**TOWN OF DOVER
PLANNING BOARD MEETING**

- Property Location: 198 Dog Tail Corners Road, Wingdale
 - Applicant: Gentle Place LLC
 - Application for: Special Permit and Erosion and Sediment Control

**Re: Lands of Fila – Accessory Apartment
Town of Dover
Tax ID# 132600-7161-00-507209**

To: Town of Dover Planning Board
From: AKRF, Inc.
Date: May 16, 2025
Re: Fila Accessory Apartment Special Permit / Site Plan – 72 Ramah Road
Rennia Engineering Design, PLLC (Applicant's Engineer)
cc: Victoria Polidoro, Esq. (Planning Board Attorney)
Joseph Berger (Planning Board Engineer)

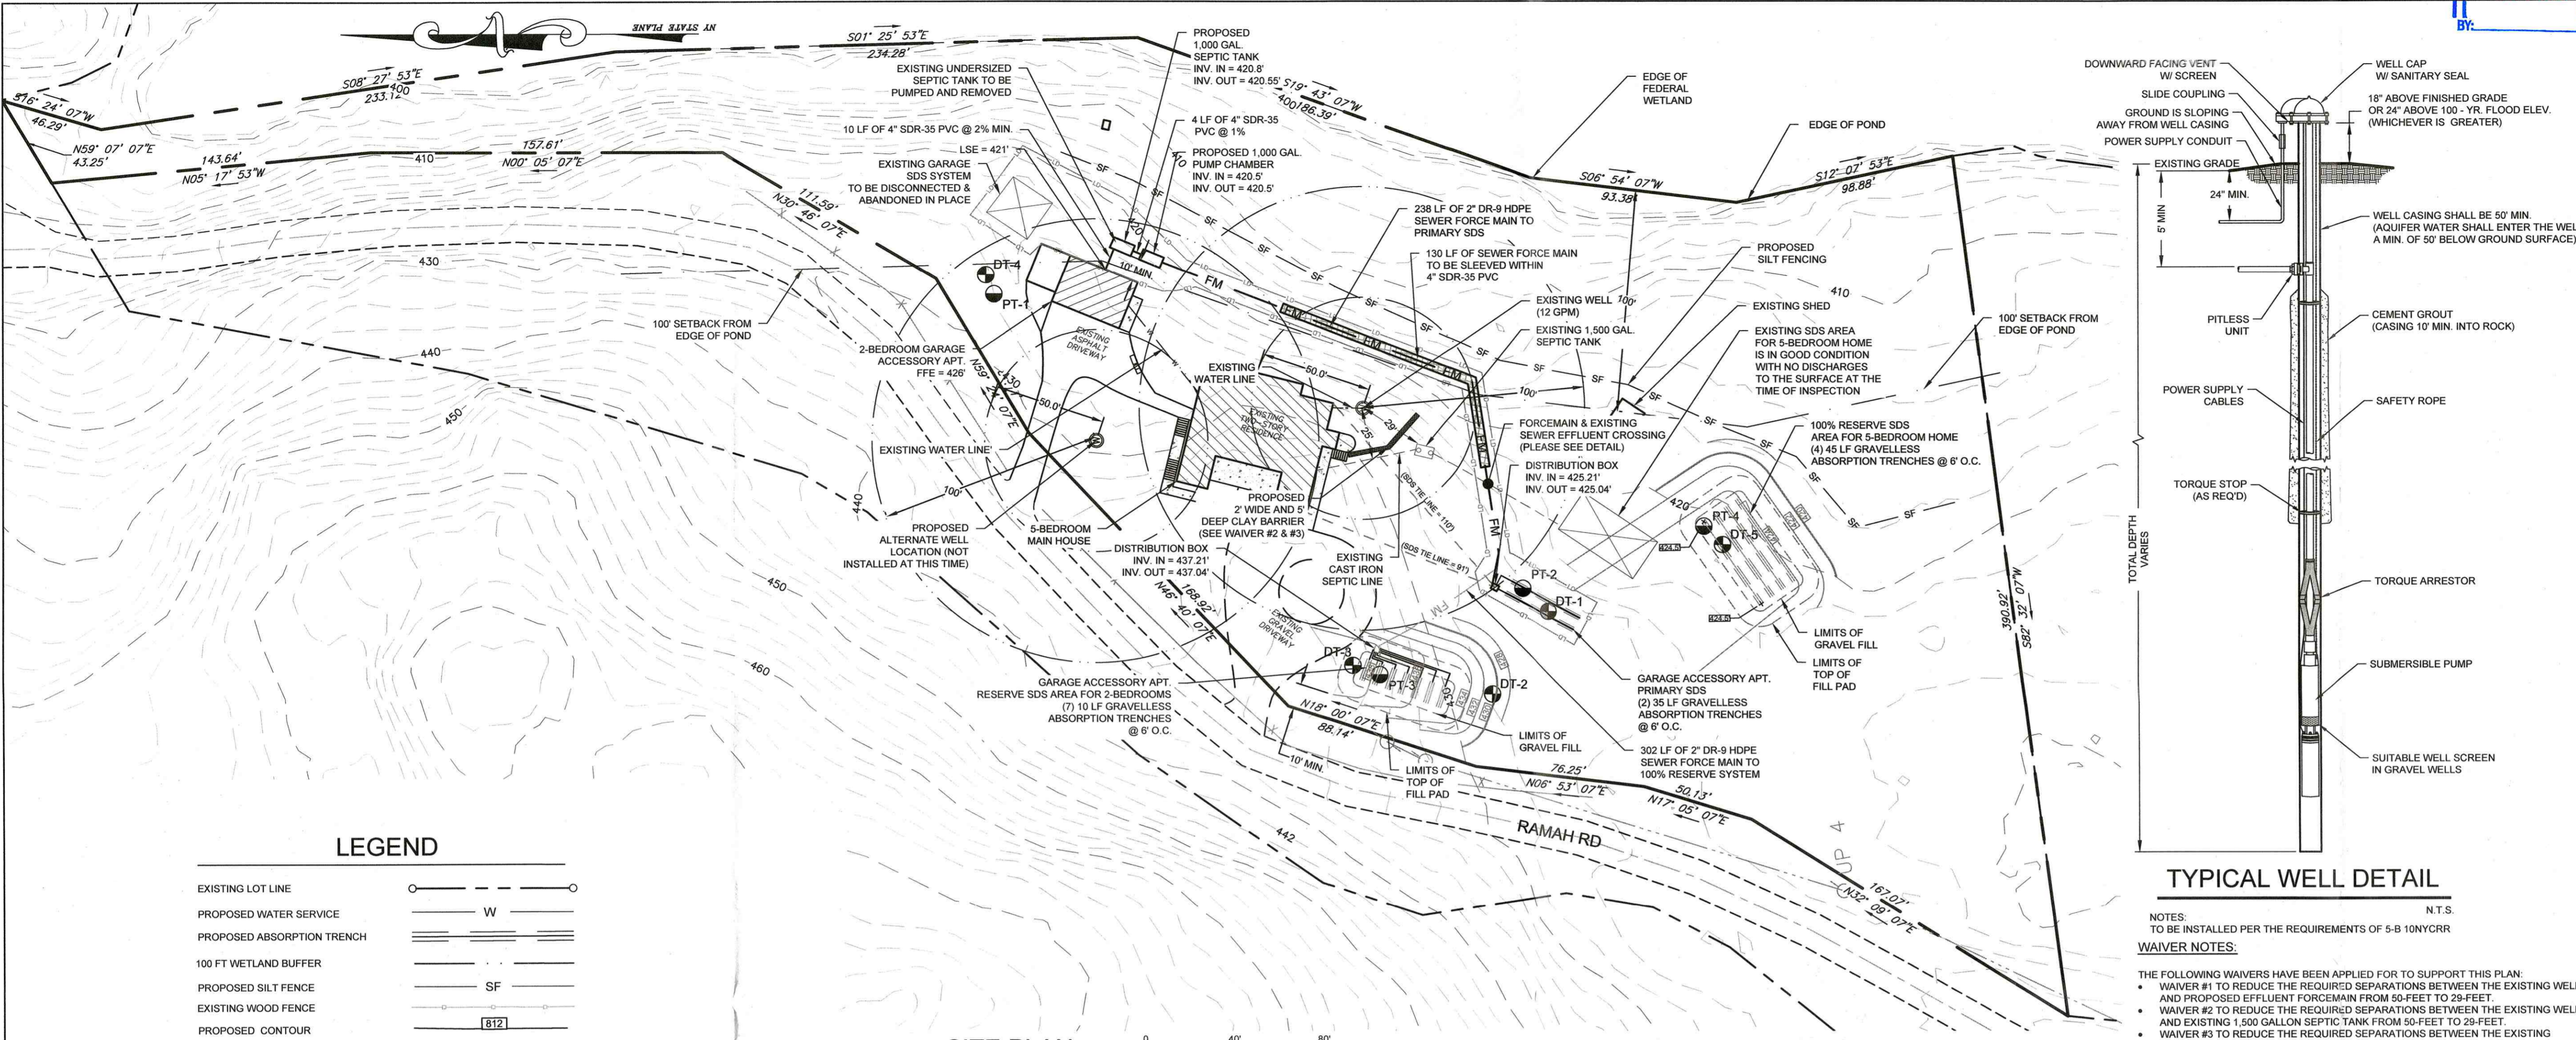
1. Payment of all fees and escrow.
2. Department of Health Approval for the methods of water supply and sewage disposal.
3. Revision of Site Plan to amend the bulk table to include a new row labeled “Maximum Floor Area – Accessory Apartment”. In the “Required” column, indicate “1000 square feet maximum”. In the “Existing” and “Proposed” columns, indicate “725 square feet”.

- c. Revision of the Site Plan to amend the bulk table to include a new row labeled "Maximum Floor Area – Accessory Apartment." In the "Required" column, indicate "1,000 square feet maximum." In the "Existing" and "Proposed" columns, indicate "725 square feet."

1. The escrow account contains sufficient balance for this project. An additional Site Plan Application Fee of \$525 has been provided with this submission for the rereview of previously approved plans.
2. Dutchess County Department of Health has approved the proposed water supply and sewage disposal system. Copies of the approvals have been included with this submission.
3. The Site Plan has been amended to include the additional notations.

As noted in the Applicant's April 29, 2025 cover letter, the site plan has been amended to include the additional notations. AKRF has no further comments on the site plan.

DRAWING: OVERALL PLAN

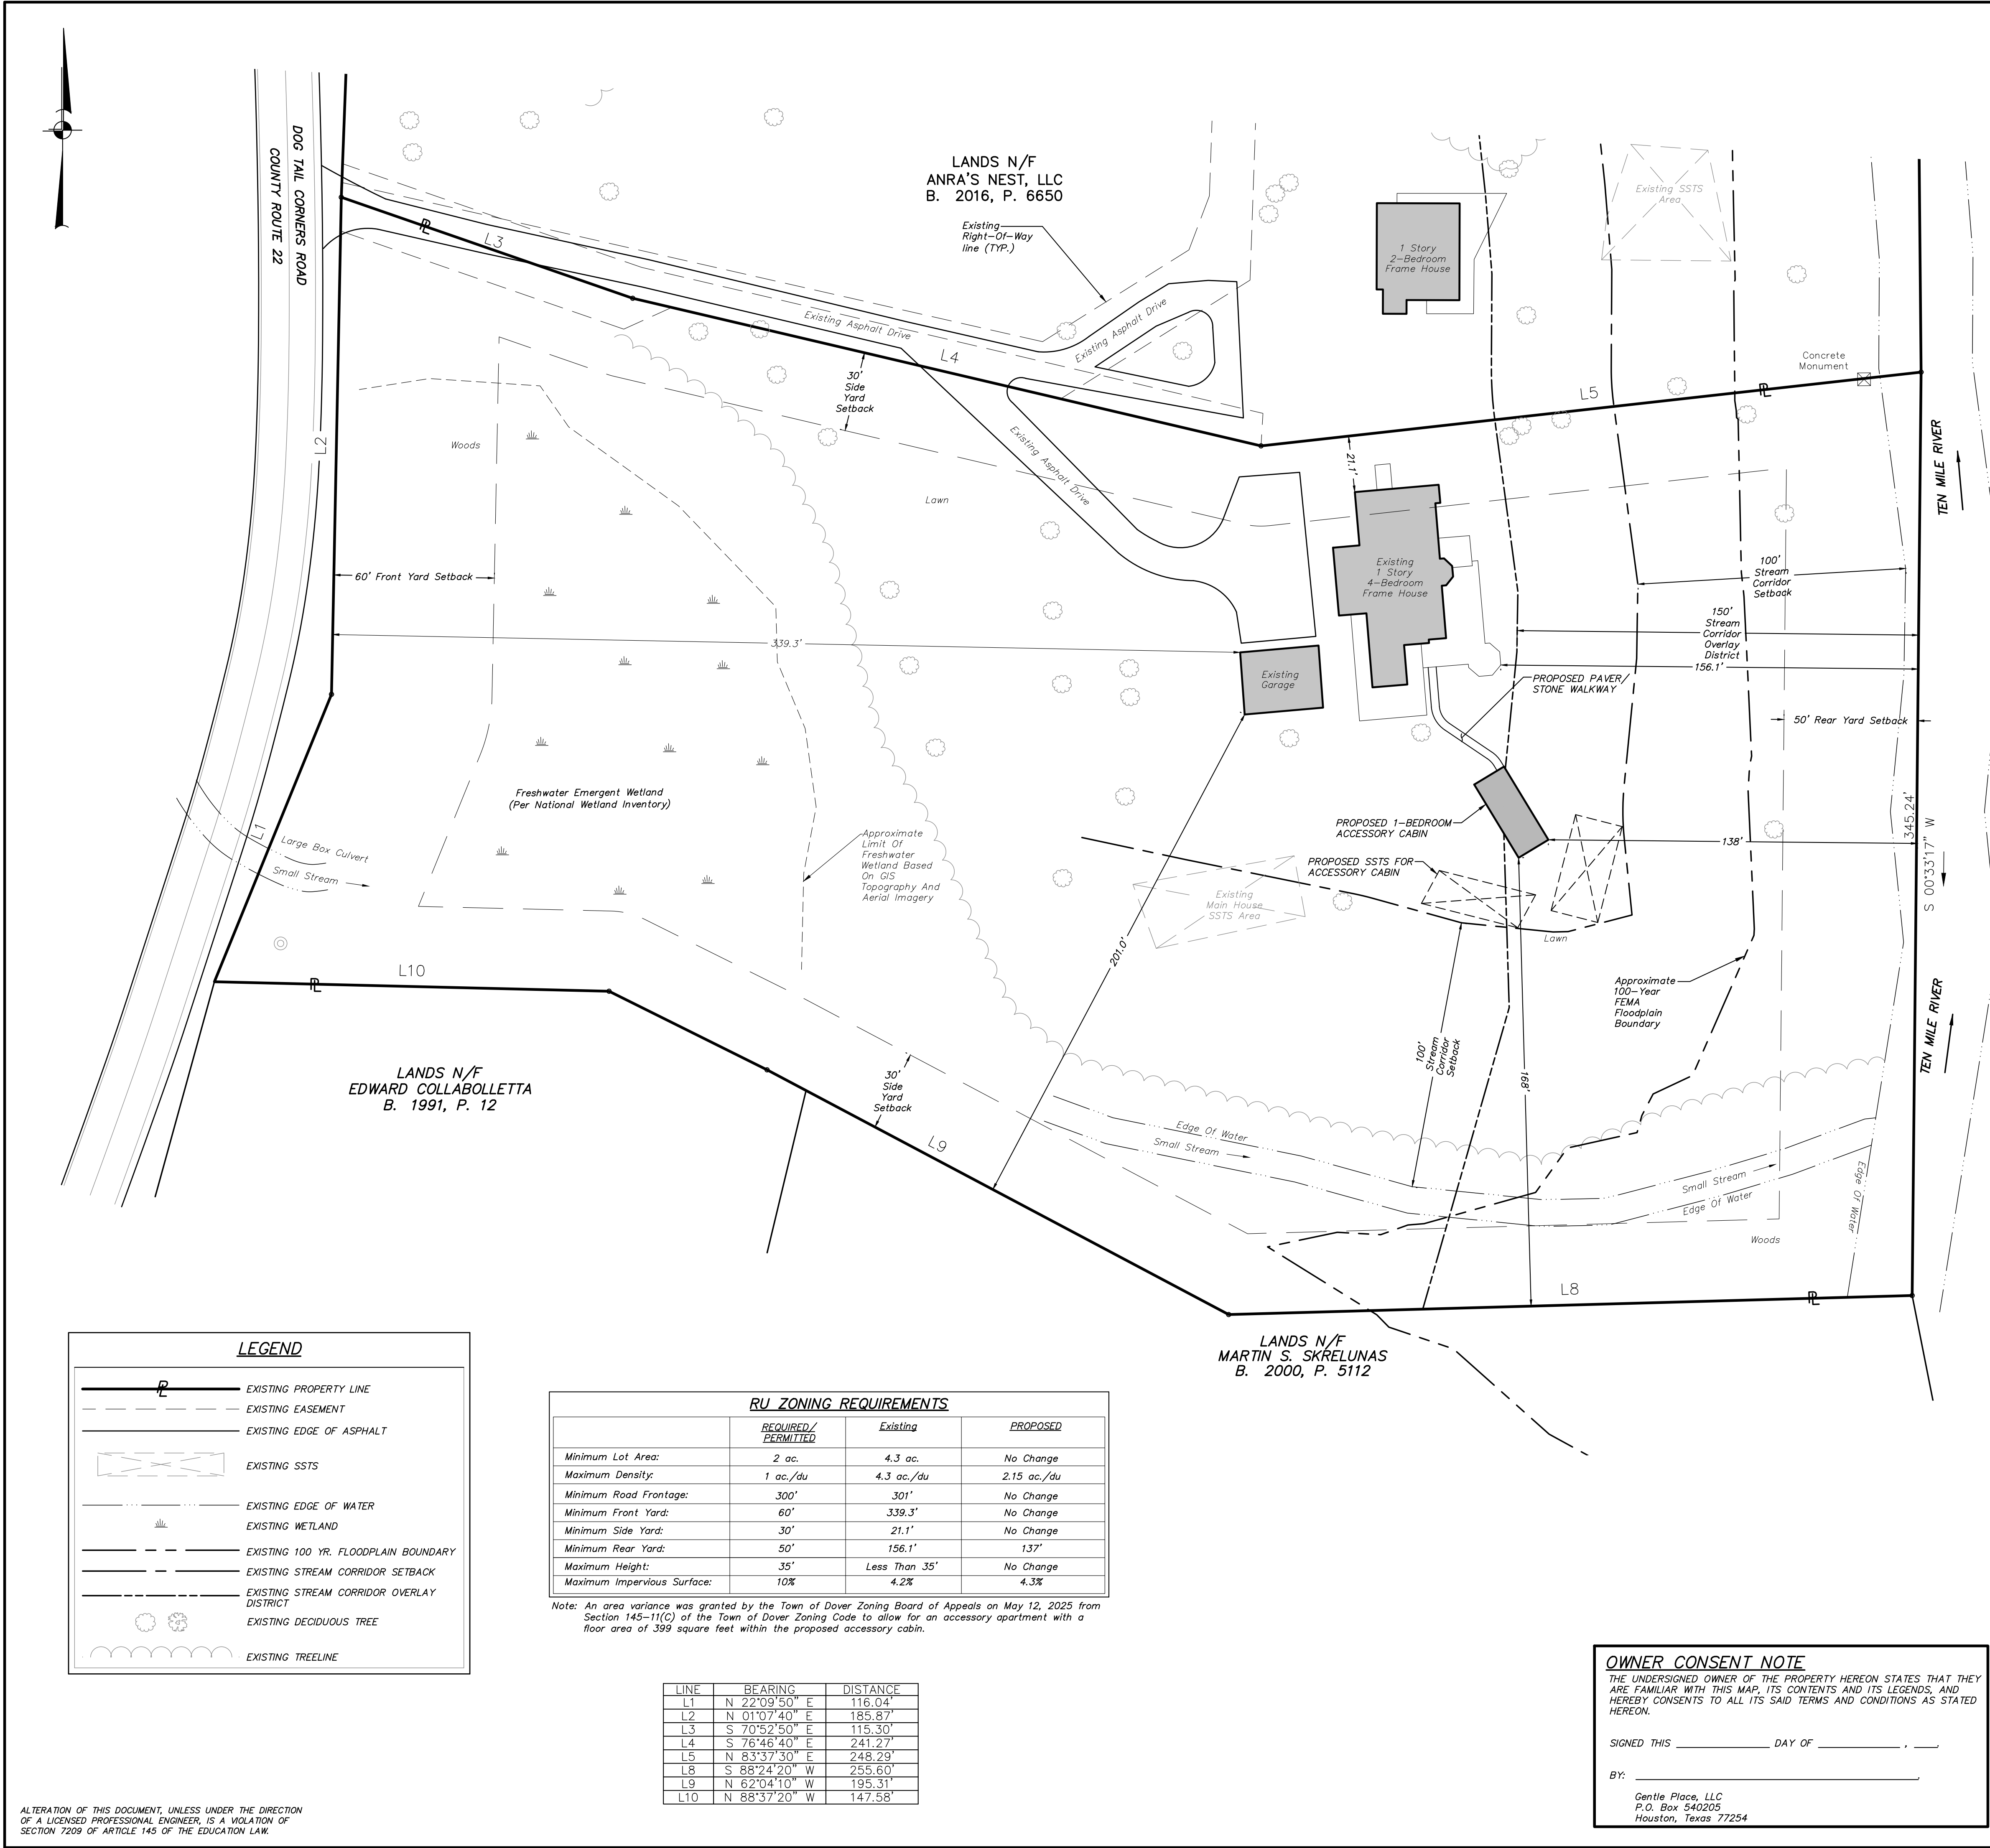
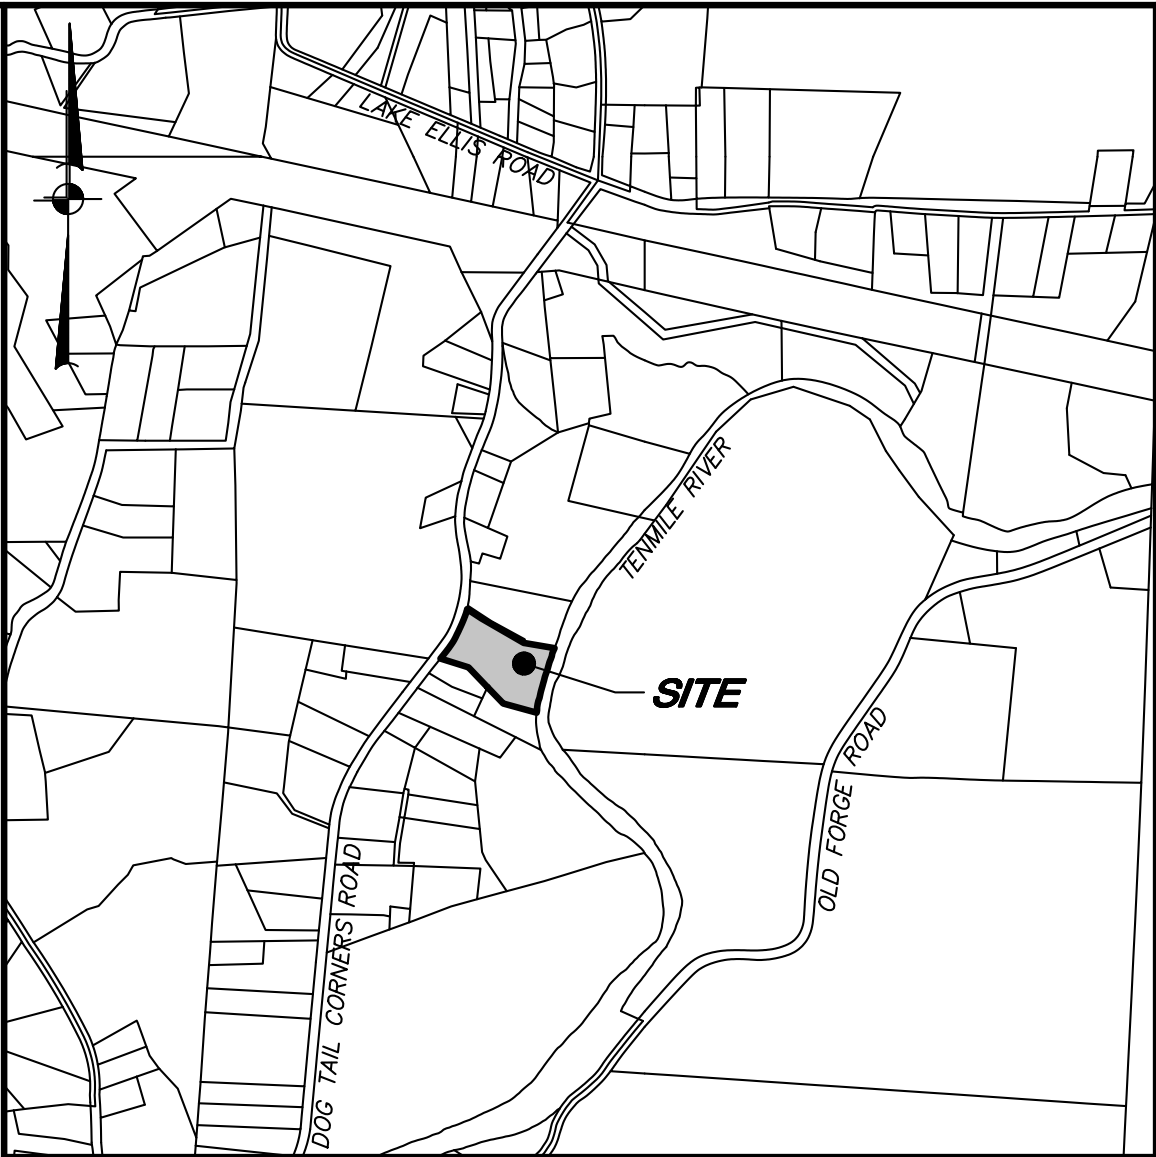
4. Since the subject property is within the Stream Corridor Overlay, a note should be added to the Site Plan that indicates any future development is subject to provisions/restrictions found at Section 145-14 of the Town of Dover Zoning Code. Additional comments related to the overlay are found below.

5. Since the subject property is within the Town's Aquifer Overlay District, specifically the Principal Aquifer Zone (PAZ). A note should be added to the Site Plan that indicates any future development is subject to provisions/restrictions found at Section 145-15 of the Town of Dover Zoning Code.

General Note #8 has been added to Drawing OP-1 on the revised site plan set.

General Note #9 has been added to Drawing OP-1 on the revised site plan set.
